**NSLPP MEETING HELD ON 06/07/2022****Attachments:**

**ADDRESS/WARD:** 104 Wycombe Road, Neutral Bay**APPLICATION No:** D295/21**PROPOSAL:** Alterations and additions to a single storey heritage listed detached dwelling including internal alterations, a first floor rear addition and a swimming pool**PLANS REF:**

**OWNER:** Arora Shweta**APPLICANT:** Arora Shweta**AUTHOR:** Robin Tse, Senior Assessment Officer**DATE OF REPORT:** 28 June 2022**DATE LODGED:** 29 September 2021**AMENDED:** 22 April 2022**RECOMMENDATION:** Refusal

south elevation

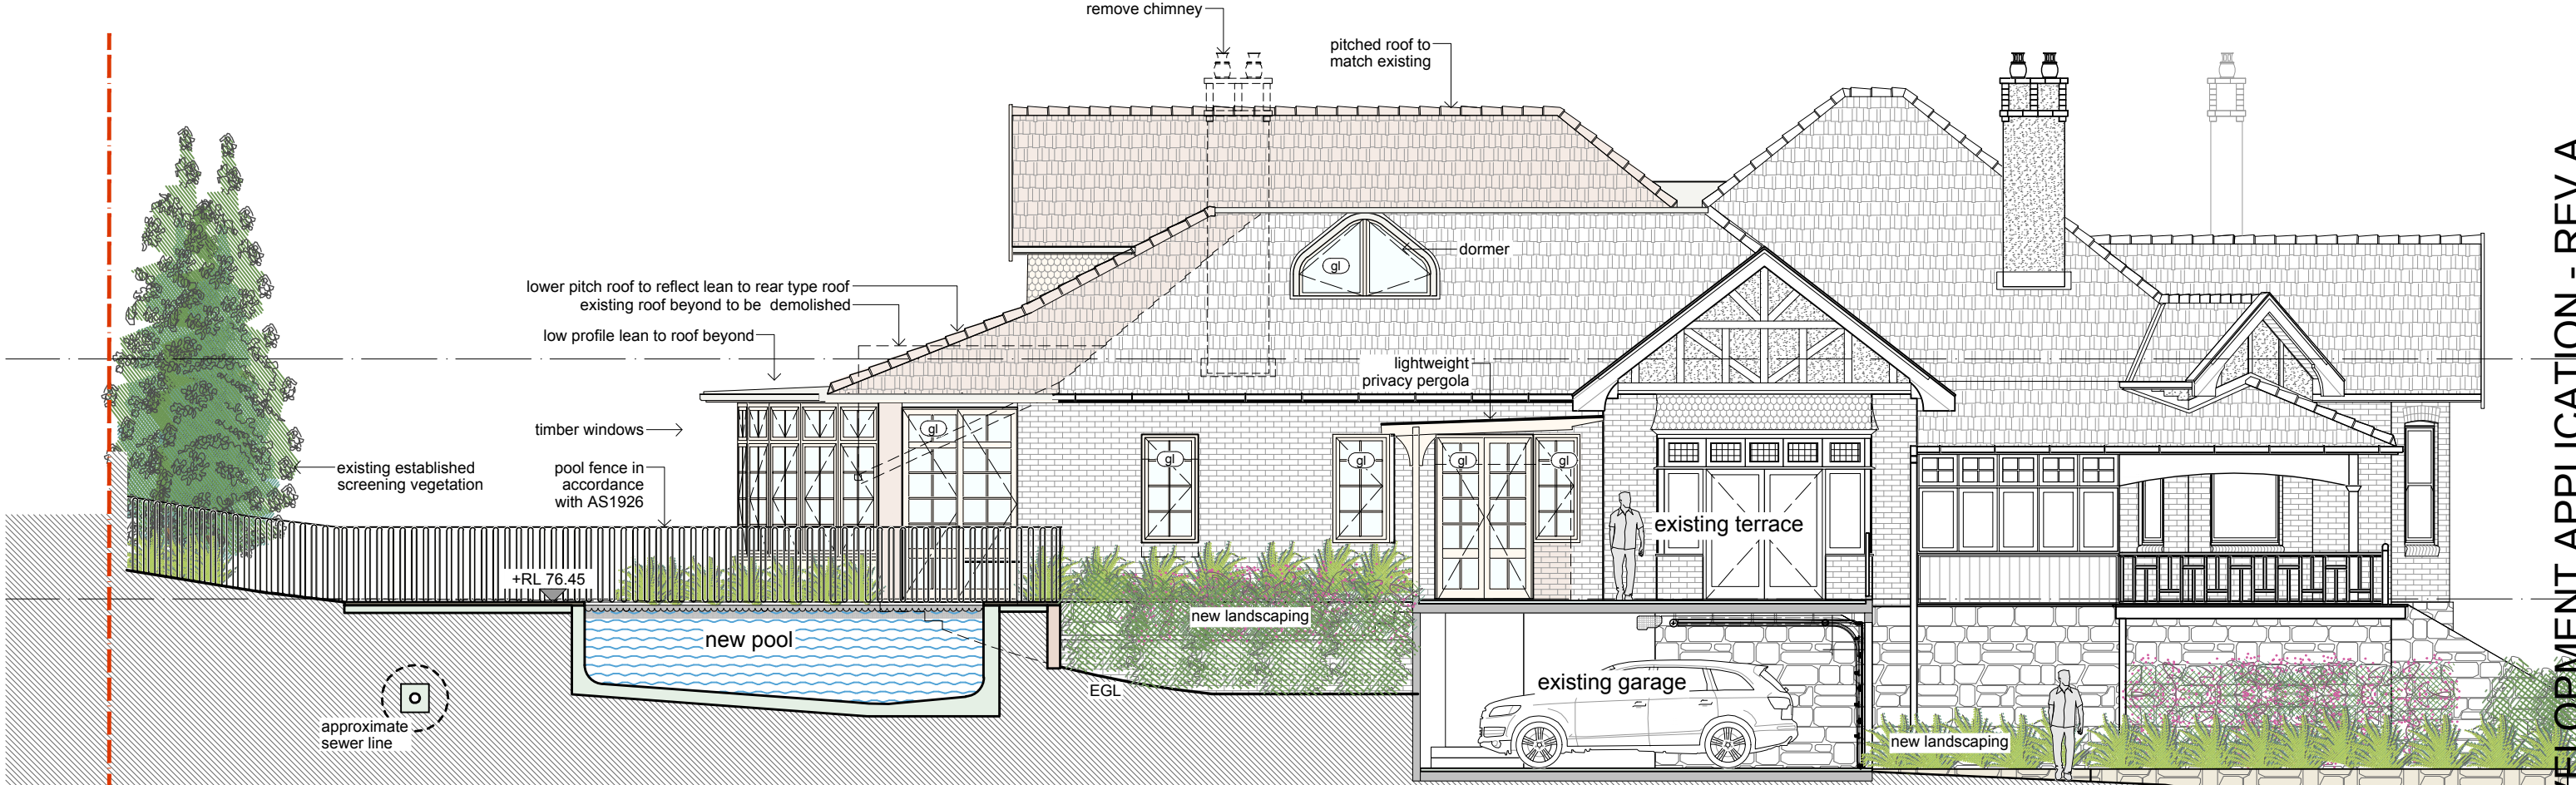
It is noted that the revised plans have reduced the scale of the proposed roof alterations to sit lower than the ridge line of the principal roof. However, the proposed rear roof addition to accommodate two bedrooms - one with ensuite, study area bathroom, foyer and circulation remains a dominant element and one that will permanently alter the distinctive and unique multi-dimensional hipped and gabled form of the original roof. The works will result in the loss of the chimney stack and include a modern dormer in the southern roof plane that compounds the impact on the visual scale of the new work.

*Council's controls require additional storeys relating to heritage items to be contained within the existing roof form. The form of the single storey rear addition also appears to be excessive and is partially housed under an extension to the main roof. The ground floor addition is possible subject to addressing the hierarchy of form relevant to the existing building. On balance, the works remain contrary to the provisions contained in NDCP 2013 Part B: 13.5.2 Form, massing, scale O1/ O2/ P1/ P4/ P5, 13.5.3 Additional storeys O1/ P1/P2; 13.5.4 Roofs O1/ P1/ P2/ P3/ P6.*
